Re: NCIRT Review and USACE Approval of the NCDMS Lyon Hills Mitigation Site / Wilkes Co./ SAW-2018-01784/ NCDMS Project # 100085

MITIGATION PLAN

Lyon Hills Mitigation Site

Subject: Mitigation Plan Report and Construction Plans
Lyon Hills Mitigation Project, Wilkes County
Yadkin River Basin HUC 03040101
USACE Action ID No. SAW-2018-01784/DWR No. 2018-1274 v1

Figure 6 - Existing Conditions Map
 Lyon Hills Mitigation Site
 Yadkin River Basin 03040101

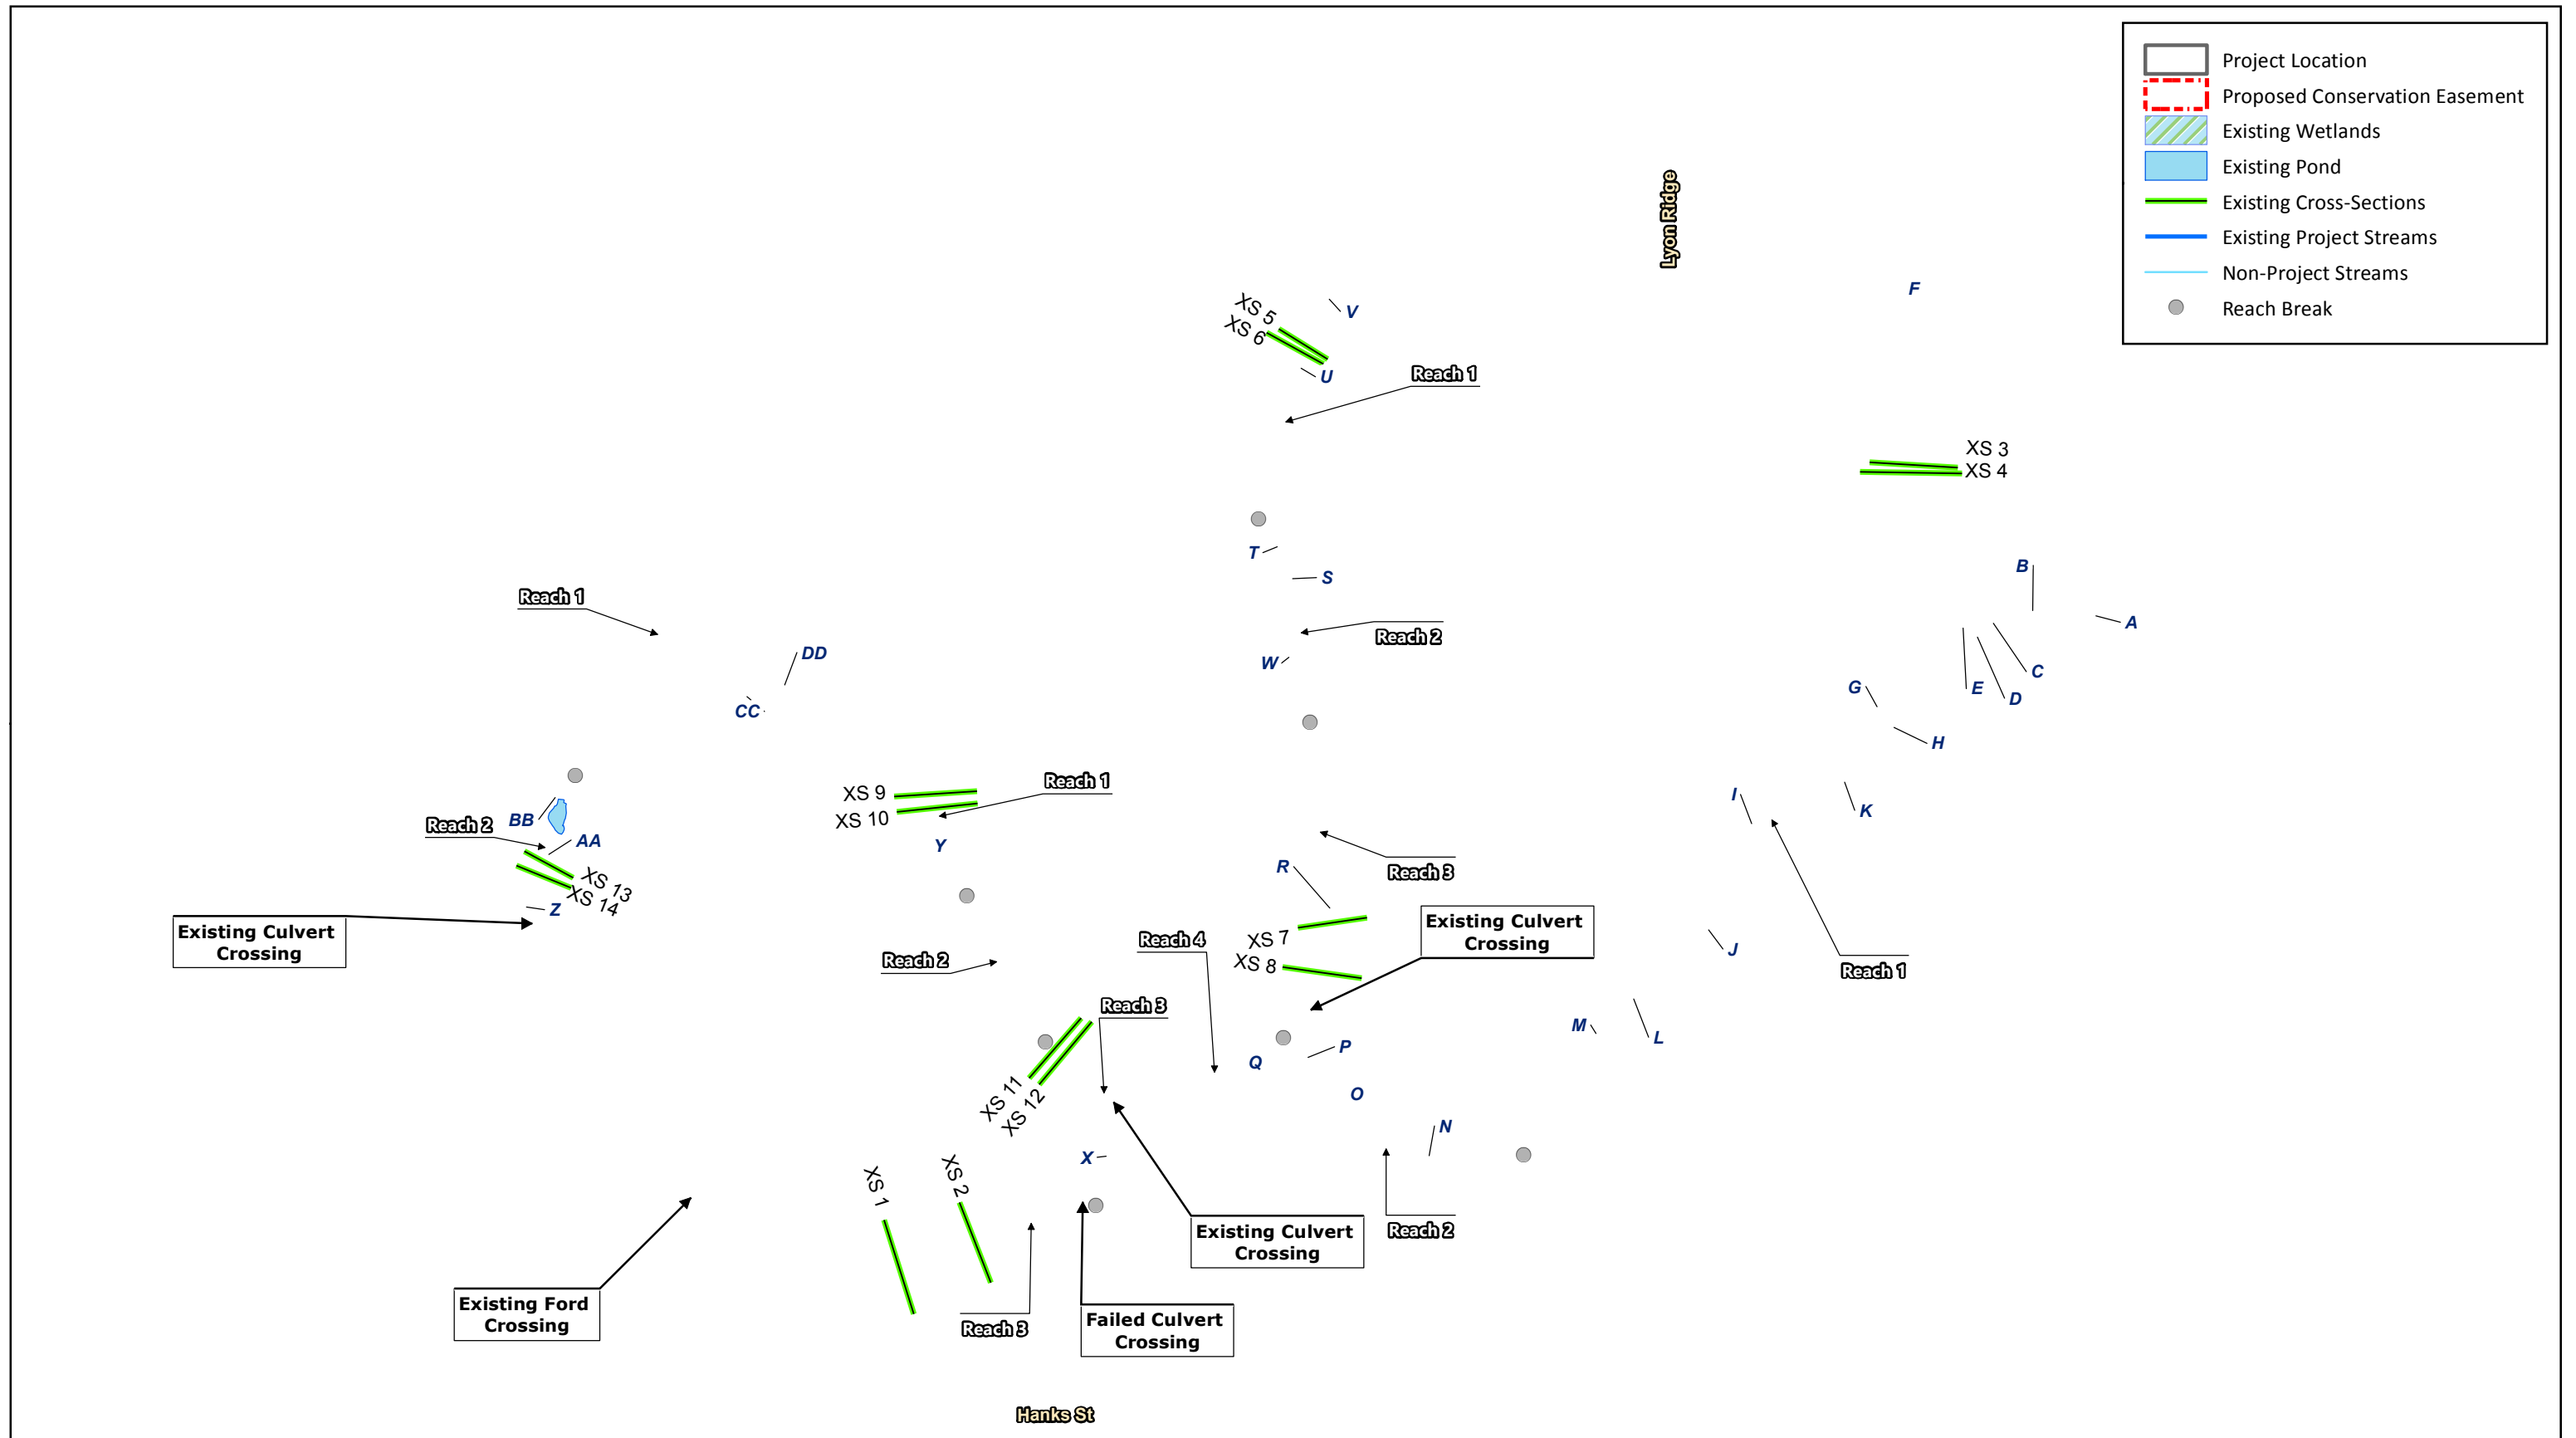
13. Figure 6 – Please indicate any existing culvert crossings.

Existing culvert crossing have been added to Figure 6.

Figure 11 - Monitoring Components Map
 Lyon Hills Mitigation Site
 Yadkin River Basin 03040101

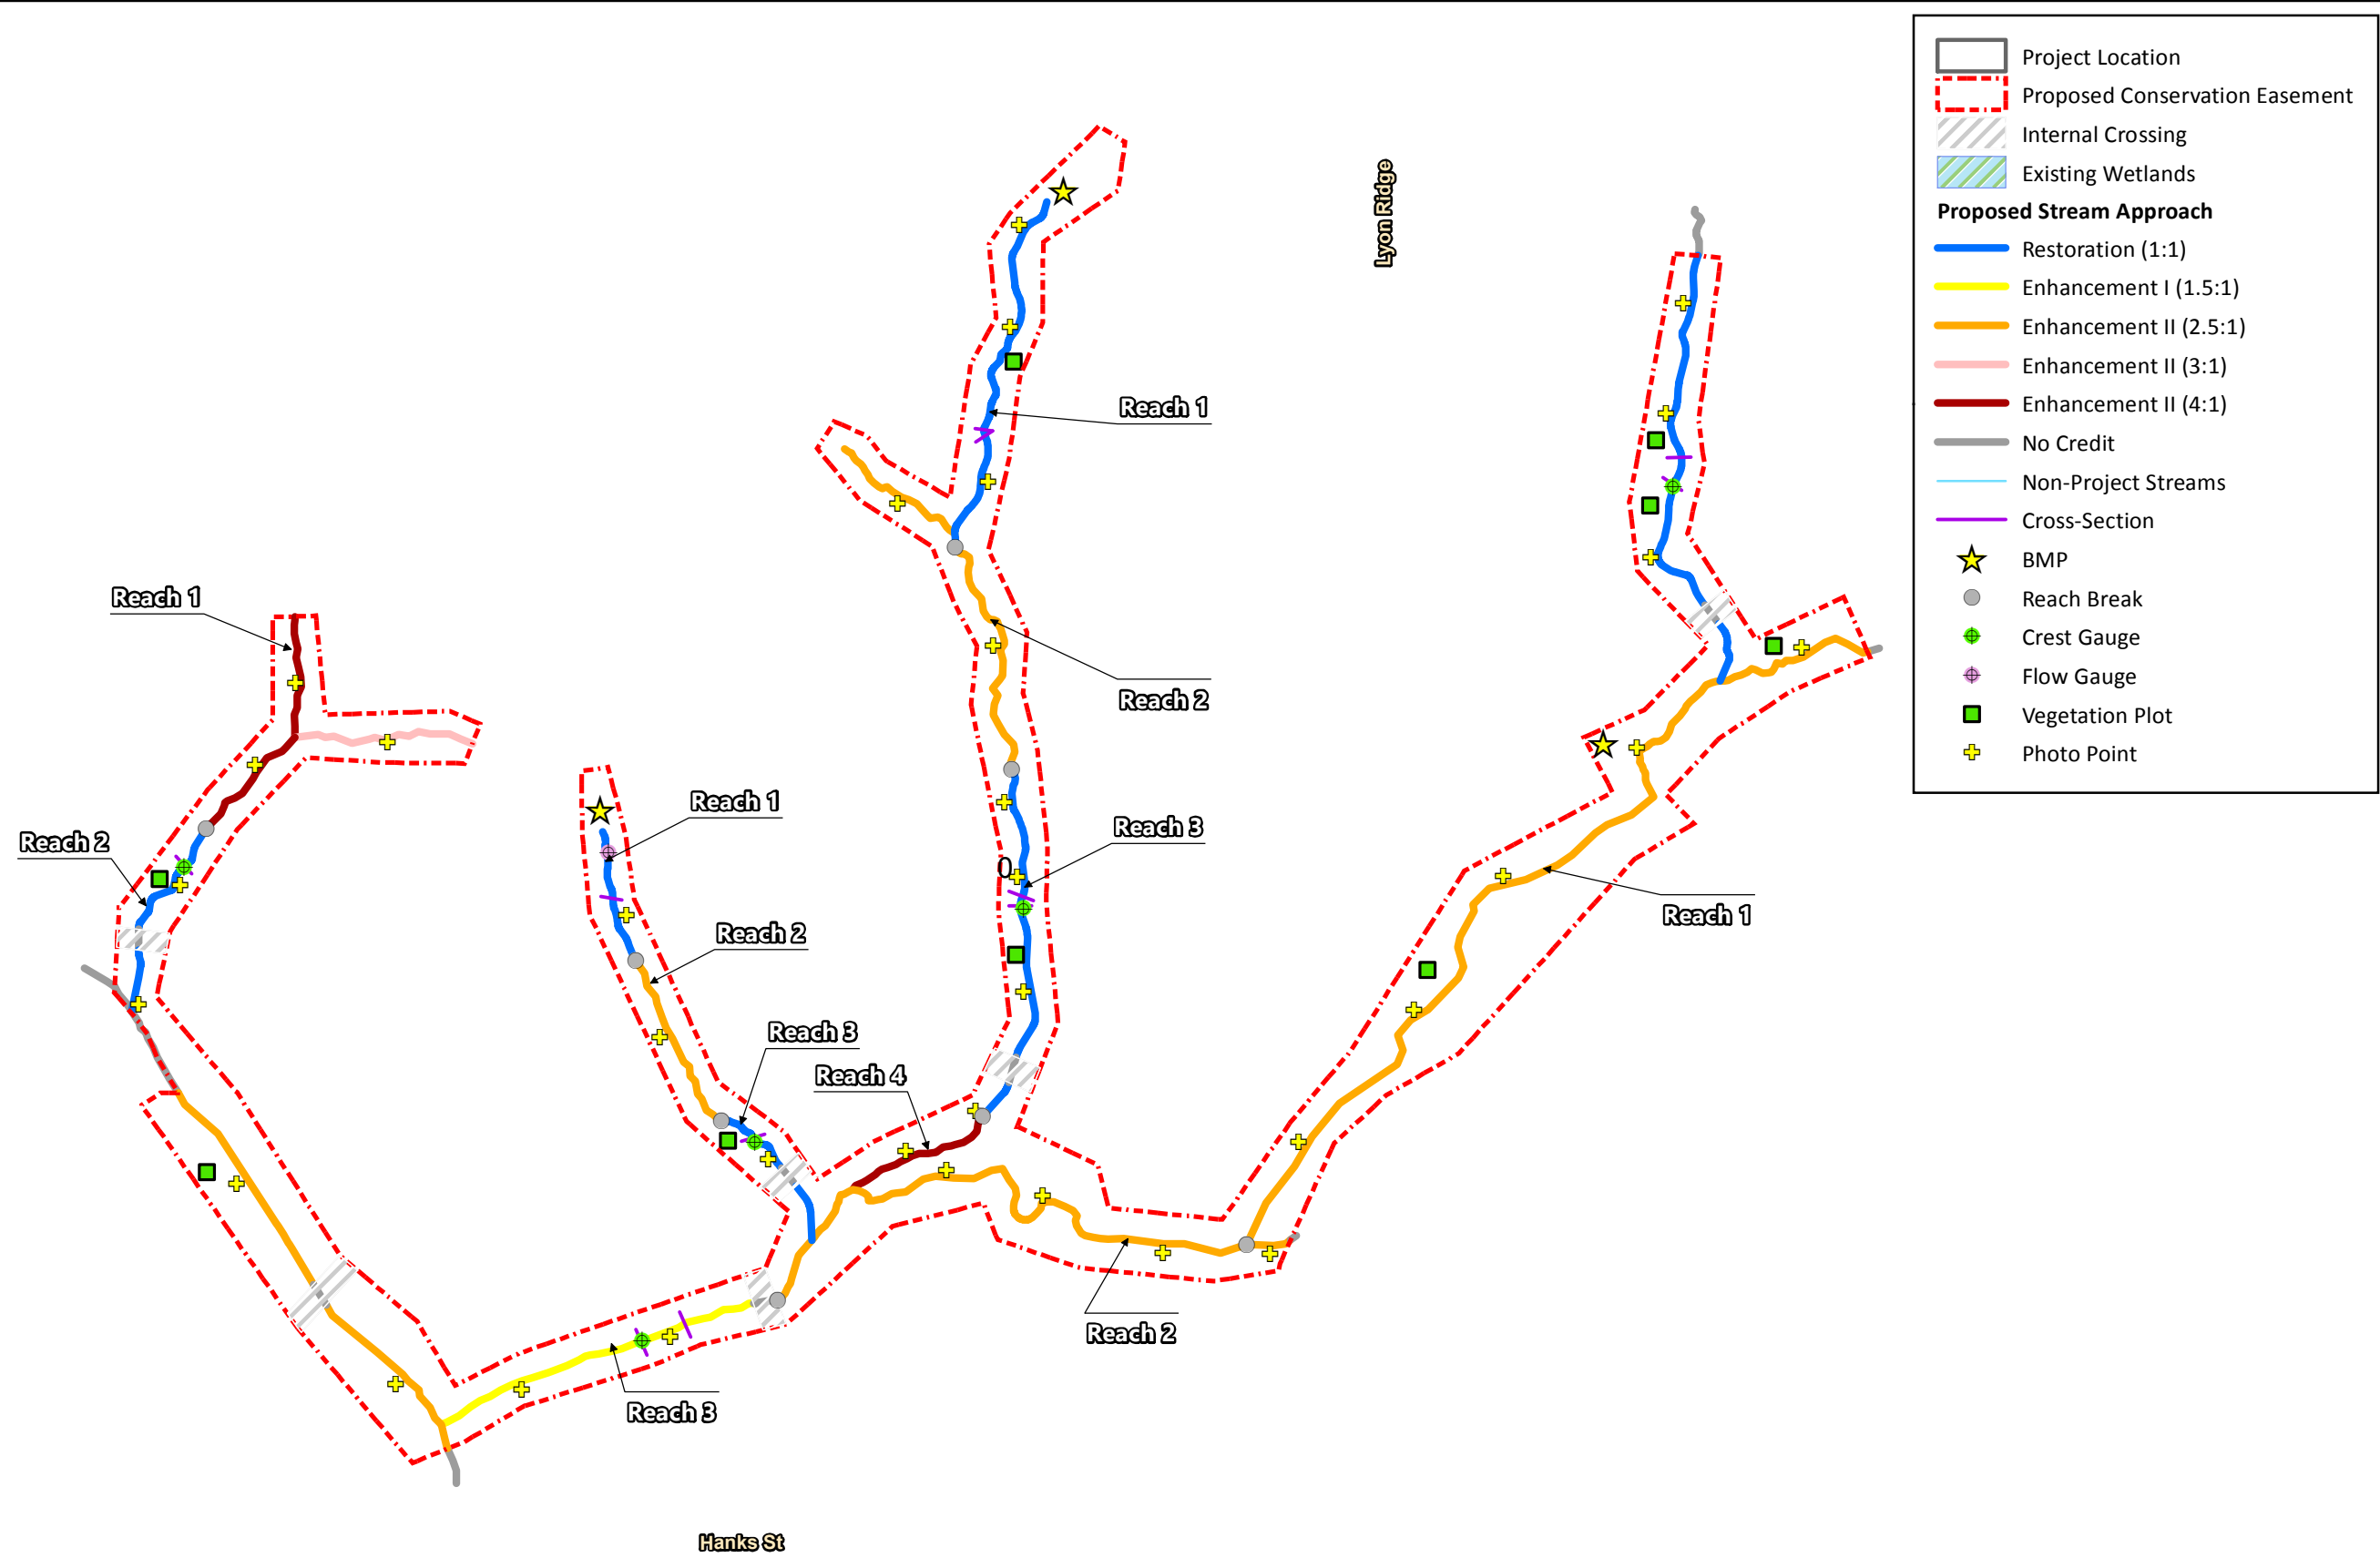
7. UT4: There is concern that raising the channel bed at the upper end will cause loss of flow. Please add a gauge in the upper 1/3 of the reach.

We have added a gauge to the upper 1/3 of UT4 as shown in Table 21 and Figure 11.

1.05

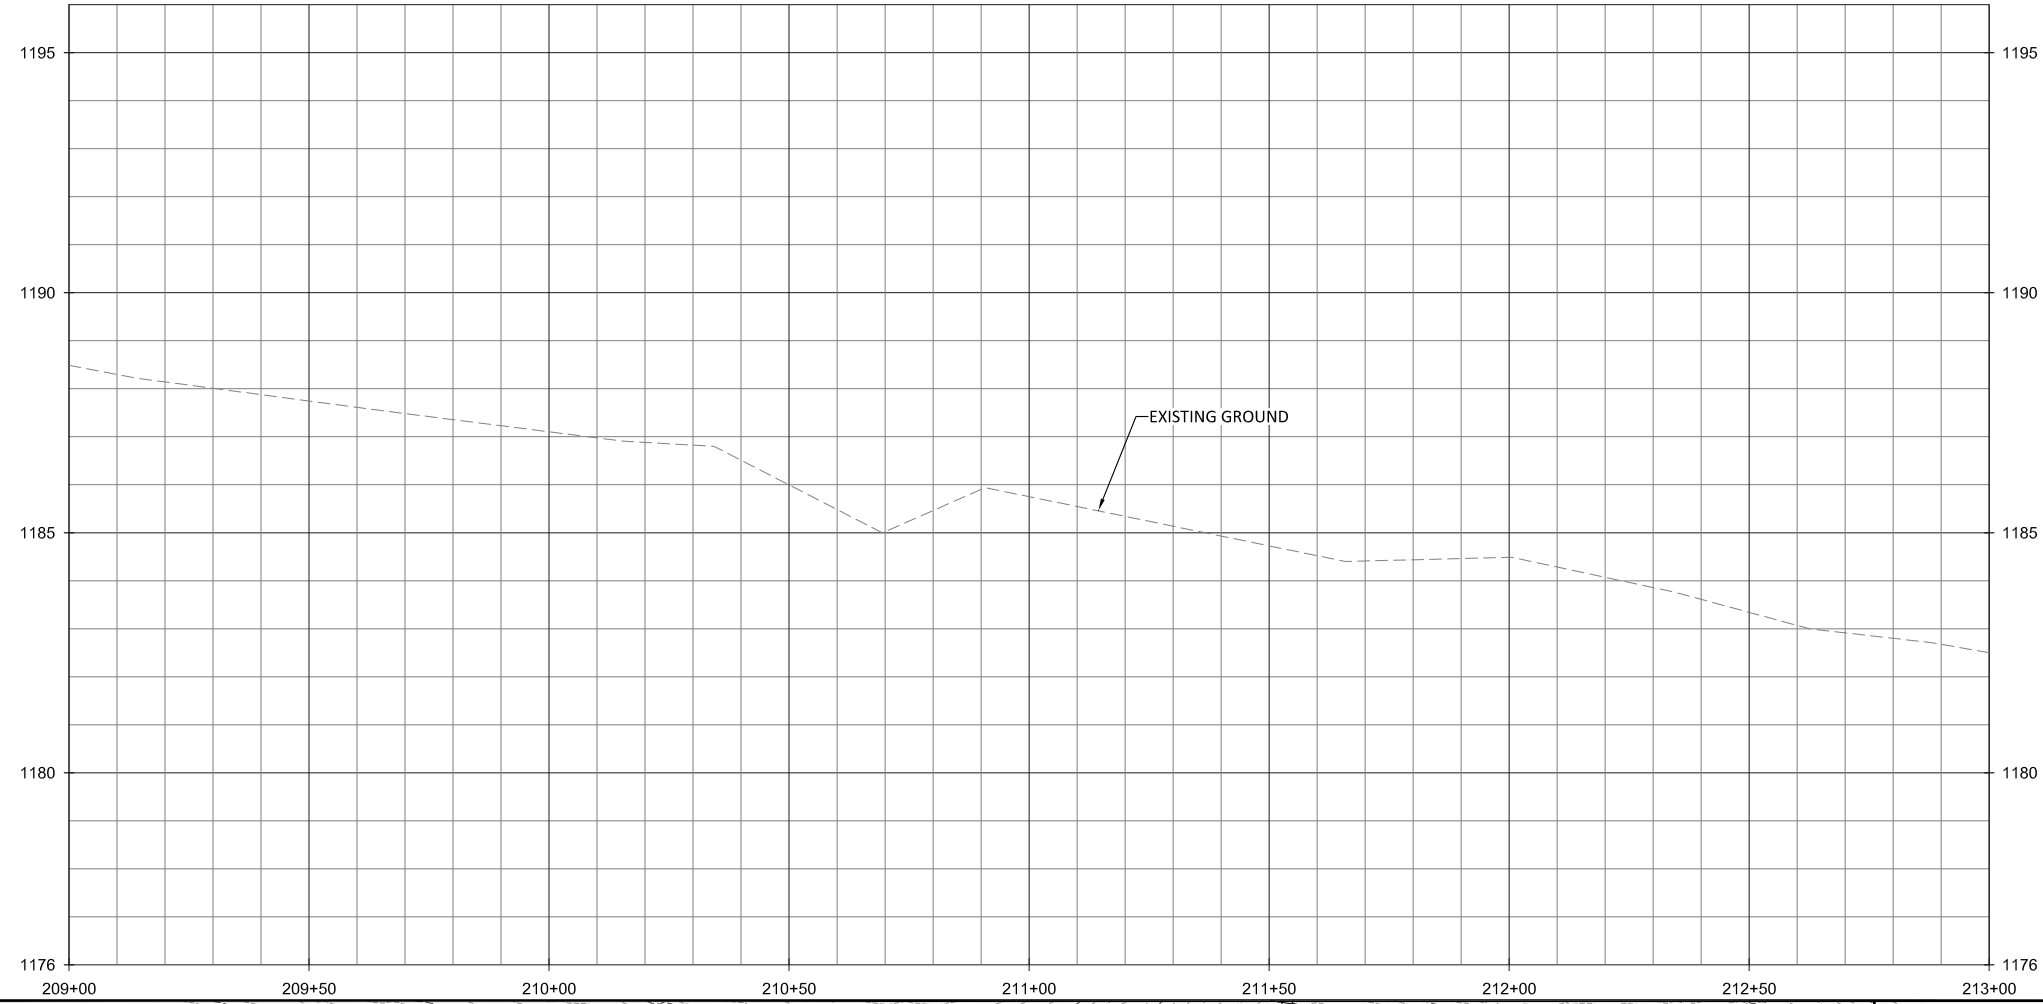
14. Sheet 1.04 – As DMS noted, please address the callout “avoid existing water line”. Please assess the condition of the pipe and remove from the easement if possible.
